# UNITED STATES PATENT AND TRADEMARK OFFICE

10/539,133

<b>Office Action Summary</b>	<b>Application No.</b> 10/539,133	<b>Applicant(s)</b> WADA, KAZUSHI	
	<b>Examiner</b> W. Wendy Kuo	<b>Art Unit</b> 2826

### **DETAILED ACTION**

FIG. 2

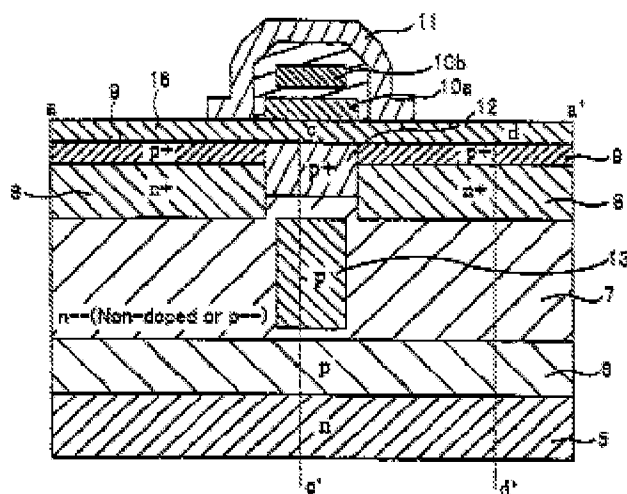
- **a semiconductor region 7 formed on a substrate 5** (Figures 2 and 3);
- a plurality of photo-sensors 1 **on the semiconductor region;**
- a transfer register 2 **formed in the semiconductor region which transfers** (column 6, lines 5-9) signal charges accumulated in said photo-sensors (column 5, lines 49-51); **and**
- an impurity region 13 (horizontal gridlines between adjacent photodiodes in vertical direction) **continuously** formed **in the semiconductor region** in a direction orthogonal to the transfer (vertical) direction of said transfer register (column 6, lines 39-52), **wherein,**
- said impurity region **is** provided at a position between said photo-sensors 1 adjacent to each other along the transfer direction of said transfer register **in the semiconductor region**

6. With respect to claim 2, Inagaki (e.g. Figures 2 and 3) further teaches that the impurity region 13 is formed at a position ***in the semiconductor region*** deeper than said transfer register (vertical CCD) (column 6, lines 2-4 and lines 39-42).

8. With respect to claim 4, Inagaki (e.g. Figure 2) further teaches that a channel stop region 12 comprised of an impurity region is formed, ***separately from said impurity region***, between said photo-sensors (photodiodes) adjacent to each other along the transfer (vertical) direction of said transfer register (column 6, lines 34-38) and in the vicinity of the surface of said ***semiconductor region***.

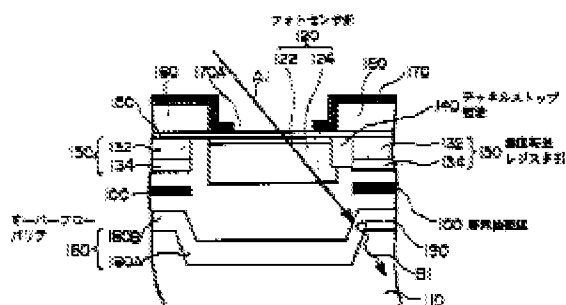
Inagaki fails to teach that the overflow barrier is in a projected and recessed shape at an interface thereof in the direction of said substrate, and a projected portion of said projected and recessed shape is disposed at a position corresponding to a position between said photo-sensors. Komatsu teaches that the overflow barrier is in a projected (shallow) and recessed (deep) shape at an interface thereof in the direction of said substrate, and a projected portion of said projected and recessed shape is disposed at a position corresponding to a position between said photo-sensors (see abstract figure) in order to prevent color mixing and smear by limiting the move of a signal charge between adjacent photosensor sections.

It would have been obvious to one of ordinary skill in the art at the time of the invention to provide the image pickup device of Inagaki with the overflow barrier of

Komatsu for the benefit of preventing color mixing and smear by limiting the move of a signal charge between adjacent photosensor sections.
